PCN/17/026/PM+MD
Product range: DC2 / Circular connectors

Title: M12 Slim Design shielding element improvement - External

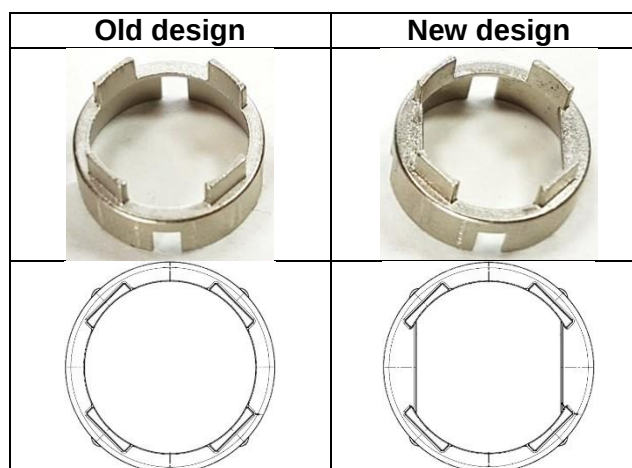
The inner contour of the shielding element of M12 Slim Design straight connectors has been changed from round shape to double D shape. This improvement secures the proper assembly and avoids the displacement of the contact carrier in assembled condition.
